BURLINGTON DEVELOPMENT REVIEW BOARD Tuesday February 6th, 2018, 5:00 PM Contois Auditorium, City Hall, 149 Church St, Burlington, VT AMENDED AGENDA

To: Development Review Board
From: Ryan Morrison, Associate Planner
Date: February 6, 2018
RE: 18-0541CA, 228 North Winooski Avenue

To: Development Review Board
From: Mary O'Neil, AICP, Principal Planner
Date: February 6, 2018
RE: 18-0590CA, 20 Allen Street

SITE PLAN / LANDSCAPE PLAN - PROPOSED

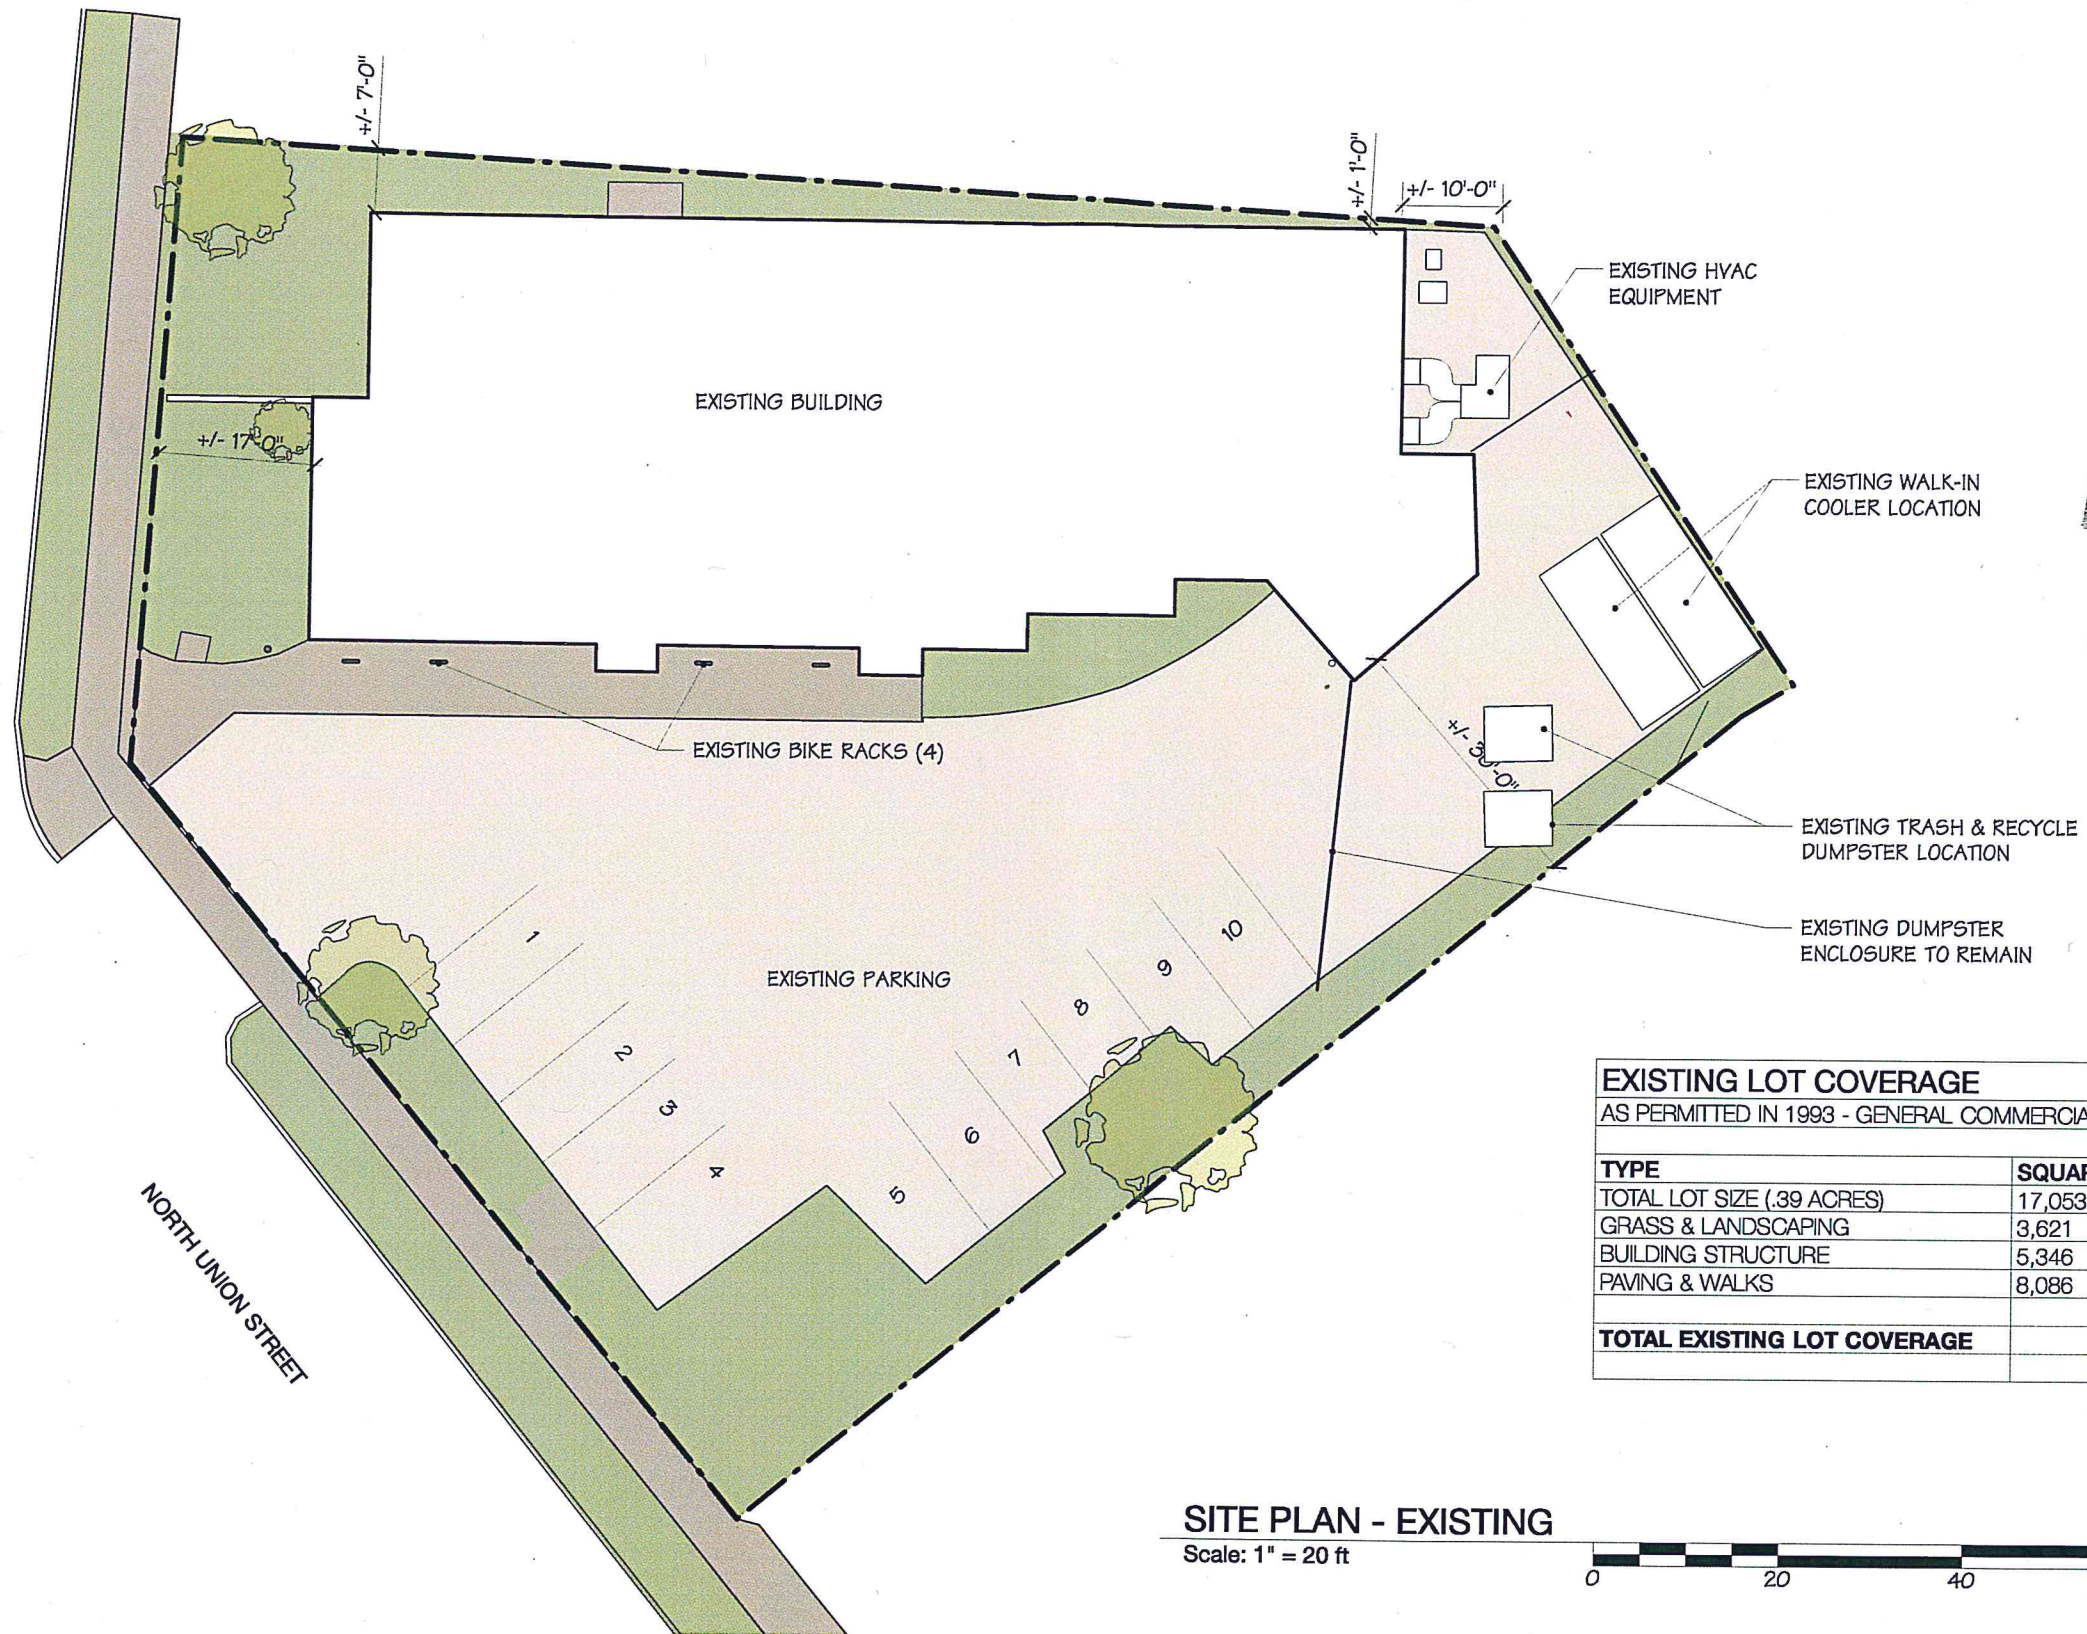
The site plan shows the existing parking lot as having 10 spaces. The applicants are considering to relocate a portion of the existing fence at the rear of the parking lot to accommodate an additional parking space, for a total of 11 spaces. This will result in a parking waiver request of 3 spaces.

Another aspect of the existing parking spaces is that they do not meet the current dimensional requirement of 9' x 20' (minimum), especially spaces 7, 8, and 9. However, these are existing spaces, as documented on previously approved site plans, and will remain to serve the facility. Any additional spaces will be required to comply with the minimum parking space dimensions.

While these 3 spaces are documented as existing from previously approved site plans, the applicant states that if the DRB does not agree that those 3 spots meet the zoning requirements, they will need to increase the parking waiver request from 3 spaces to 6, which would represent a 43% parking waiver.

6. The site plan shall be revised to show the new parking space (space #11) with a dimension of 9' x 20'.
7. The applicant shall report to the Department of Planning & Zoning every year for 3 years following construction with a summary of actual parking demands.

1 ROOF PLAN
1/8" = 1'-0"

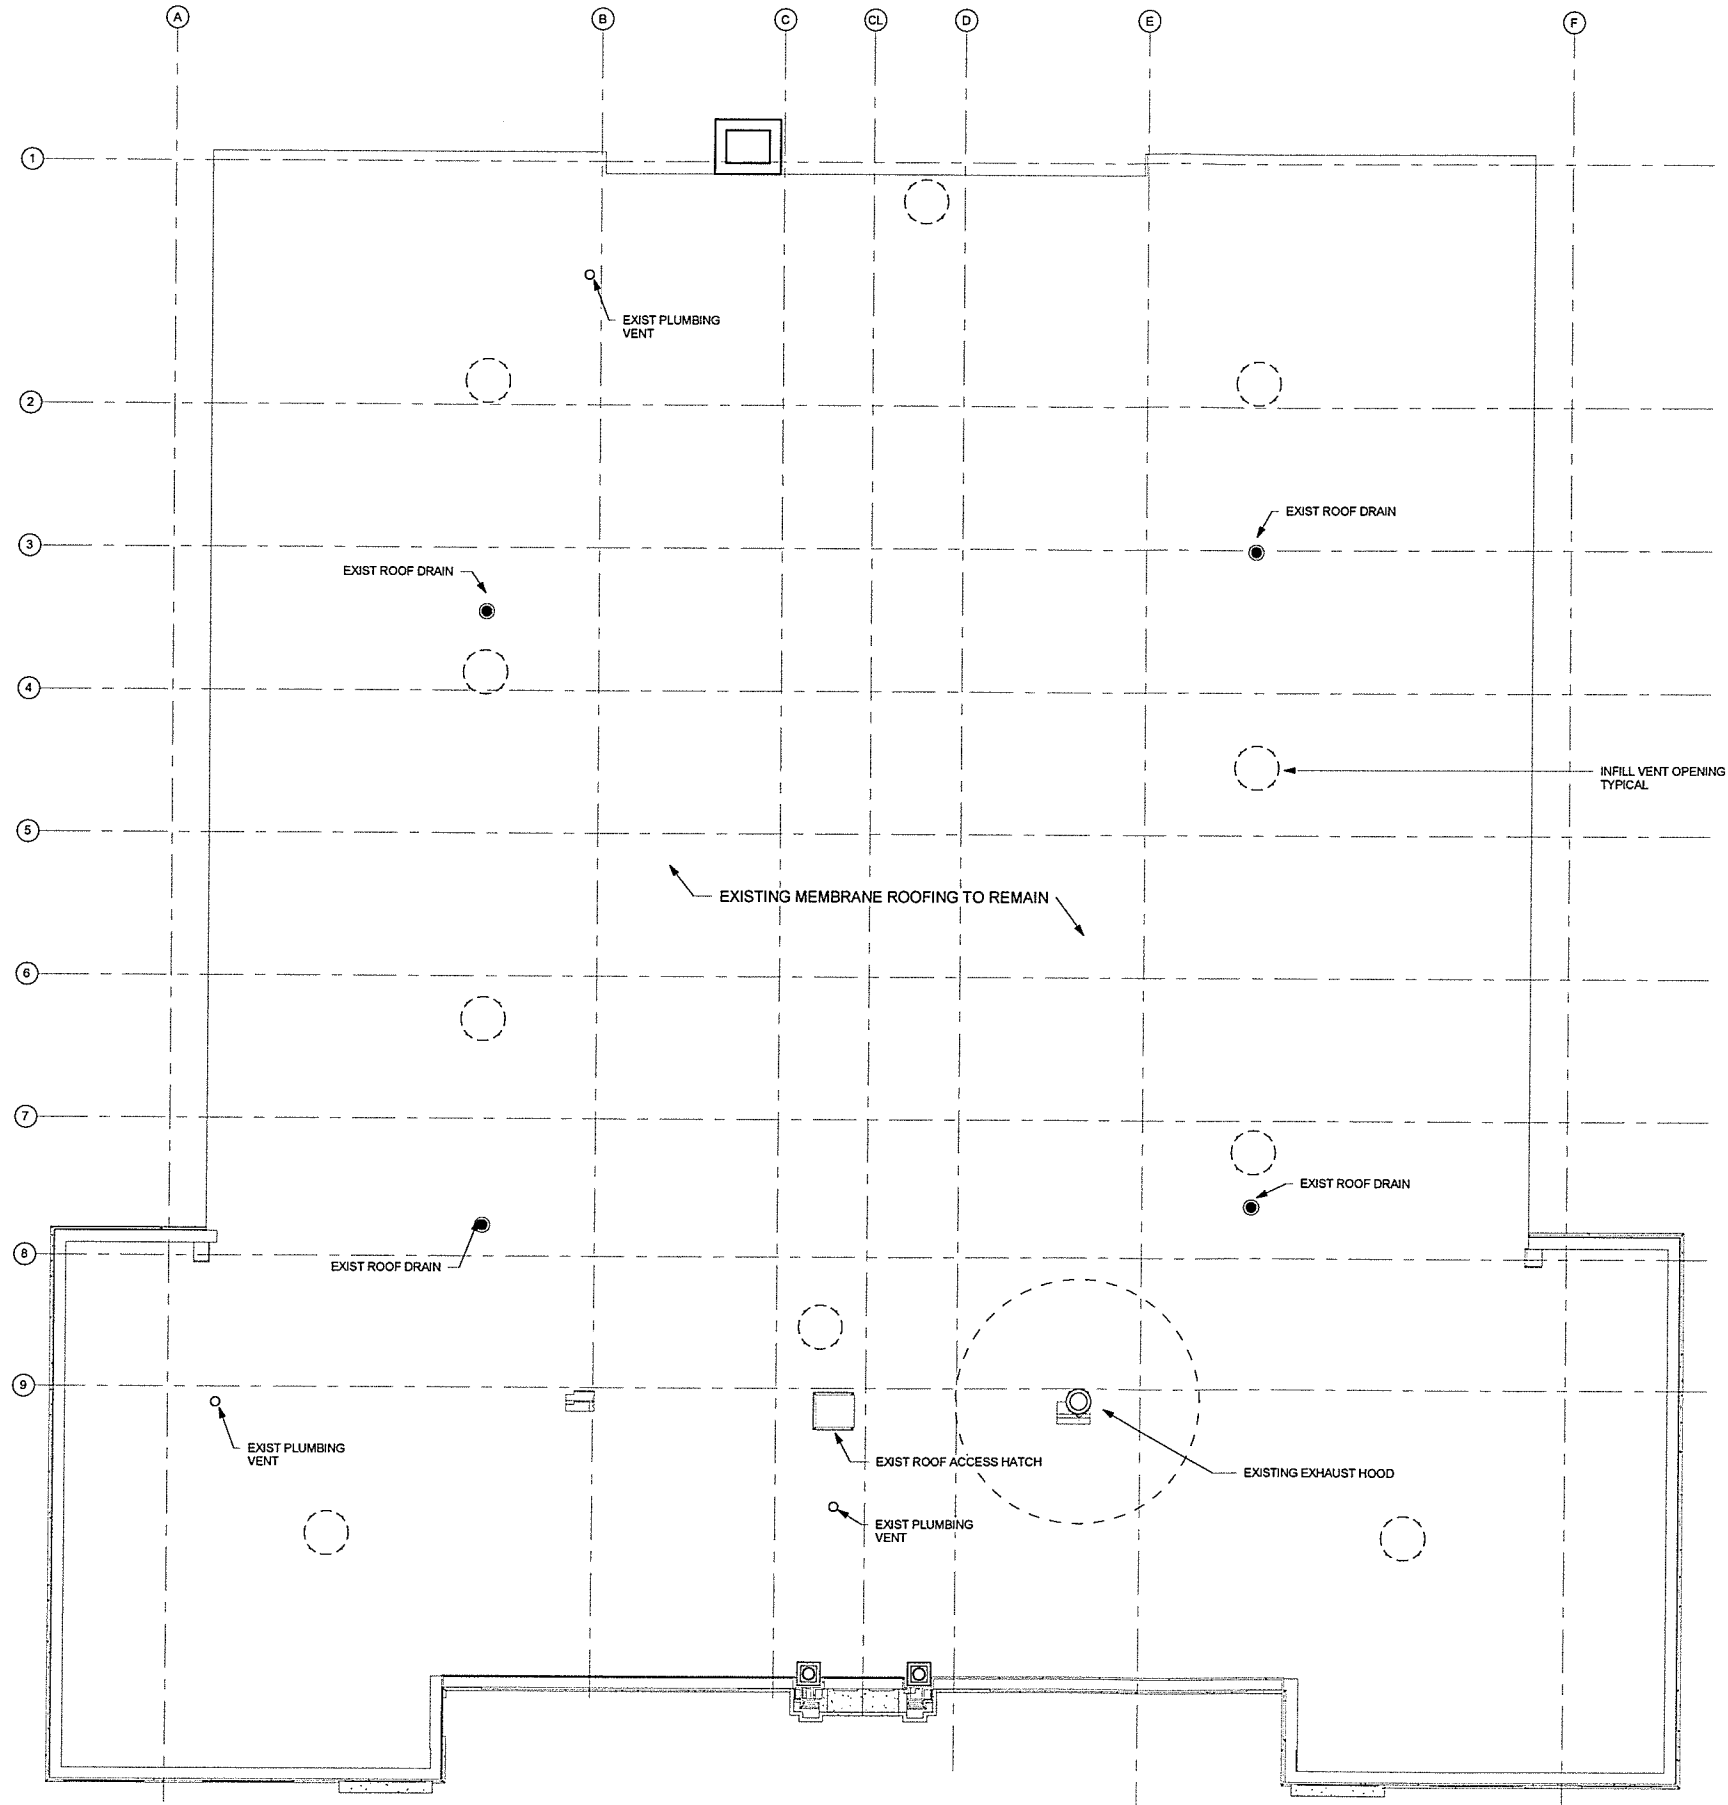
Some roof vents will be removed. See Plan A2.4.

Other than removal of roof vents and extrusion for an elevator shaft (noted in consultant's report) no change is proposed to the existing membrane roof. See plan A2.4 for details. **Affirmative finding.**

sheet no.
C1.0

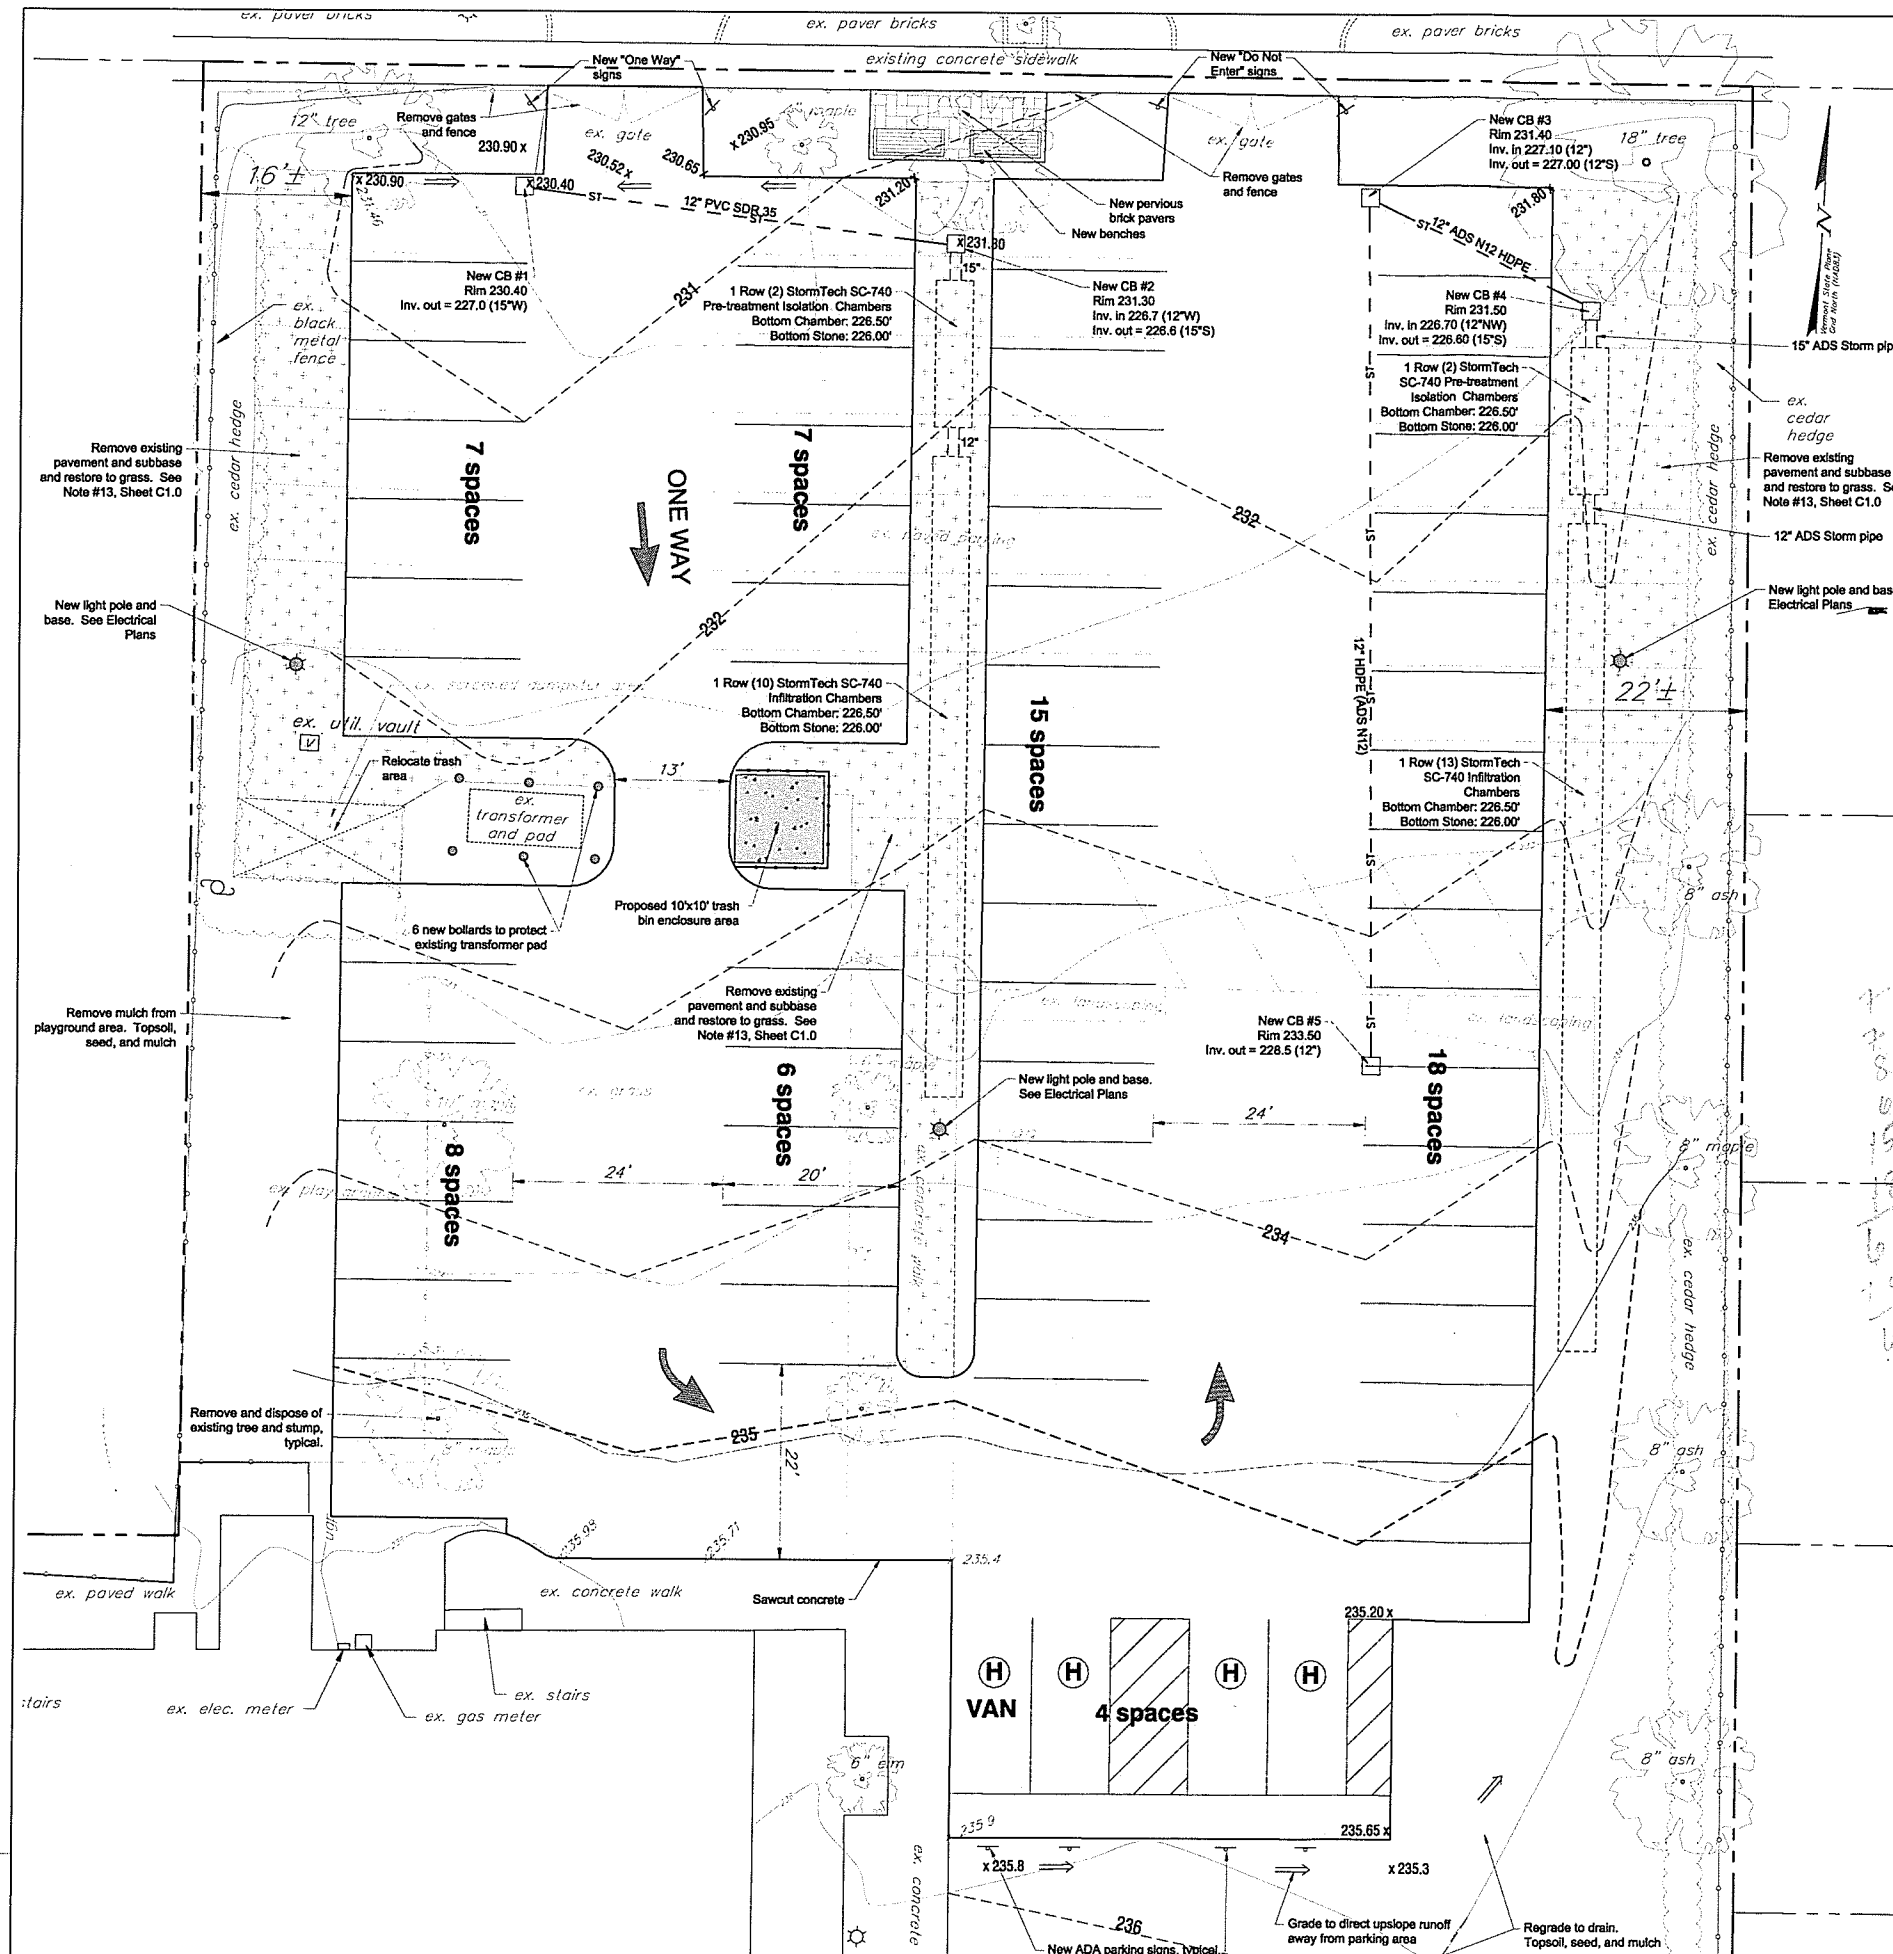
An electrical transformer pad will remain but gain protective bollards. The trash enclosure will be relocated, and be enclosed on four sides. (See Plans C1.0 and C2.4.)

Total bicycle parking required: 31 short term and 3 long term. The applicant illustrates the proposed parking on a revised site plan. (C1.0 and C1.2.)
